UNITED STATES PATENT AND TRADEMARK OFFICE

Office Action Summary

09/954,806

3. Claims 1, 4-7 and 13-17 stand rejected under 35 U.S.C. 103(a) as being unpatentable over the EP 997960 reference.

Figure 4 shows the thickness of a positive electrode active material layer wherein P represents the electrode layer (section 0119).

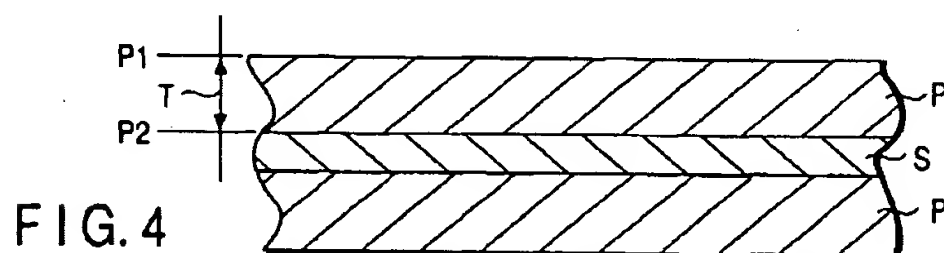
It is also disclosed that the positive electrode has a structure in which an electrode layer containing an active material is carried by one or both surfaces of the collector (section 0018). It is also disclosed that the negative electrode has a structure in which an electrode layer containing an active material is carried by one or both surfaces of the collector (section 0026)

The EP'960 reference teaches that the thickness of the positive electrode layer should be 10-100 μm ; it follows that where positive electrode layers are formed on both surfaces of the collector, one positive electrode layer has a thickness of 10-100 μm , naturally, the total thickness of the two positive electrode layers formed on both surfaces of the collector is 20-200 μm . It is also disclosed that **the upper limit in the thickness is preferably 85 μm** (section 0119/ 0158) (*← emphasis added*). Hence, the EP'960 reference envisions the claimed thickness, at least, from 80 to 100 μm when one layer is formed, and at least, from 80 to 200 μm when two layers are formed thereon.
